In-Band Signaling Field (IBSF)

(Clause 177)

Comments 359, 469, 470, 471

Xiang He, Huawei

Table 177–2—Pad format

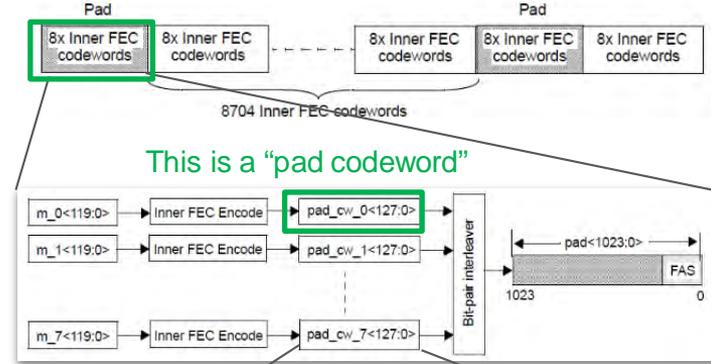
As it appears now the IBSF content is not defined at all, since it is "The details of how to use the IBSF are beyond the scope of the standard". If so, it is implementation-specific, and a compliant receiver is not required to decode it.

The words "link and signal-related information, such as receiver state, channel response, FEC statistics, etc." are a promise that cannot be fulfilled unless the content is defined.

To eliminate the TBDs in Table 177-2 it is suggested to follow a lot of precedent cases and define the IBSF content as reserved (transmitted as zeros, ignored on receipt). This can be changed in a future draft if we decide to define a meaning for these bits in the standard.

Change from
"It may be used to carry link and signal-related information, such as receiver state, channel response, FEC statistics, etc. The details of how to use the IBSF are beyond the scope of this standard"

to
"The assignment of the IBSF field is provided in Table 177-2".

Replace all instances of "TBD" in Table 177-2 with "Reserved" with a footnote "Transmitted as all zeros, ignored on receipt", with editorial license.

The contents of the IBSF are never explicitly defined. As such, this field should be deemed to be outside the scope of this standard, at least until such time an alternate proposal is adopted.

The contents of the IBSF must be sufficiently rich to prevent degradation of the transmitted signal, e.g., due to baseline wander.

Scramble the contents of the IBSF using an n-bit scrambler, with scrambler state retained from the previous IBSF.

The scrambler length should be at least 10 bits. A 13 bit scrambler is suggested.

The source of content of the IBSF is not defined.

Define a management control variable tx_ibsf (912 bits) and along with MDIO registers. Specify the default value is all zeros.

1. Change the term “IBSF” to “pad bits”.
2. Use the similar method that defined the pad bits in AM to define these “pad bits”:
 - The 912-bit “pad bits” in each 1024-bit pad are scrambled 0’s.
 - Use self-synchronizing PRBS13 scrambler, with any non-zero initial state.
 - Scrambler state is retained from the previous pad.
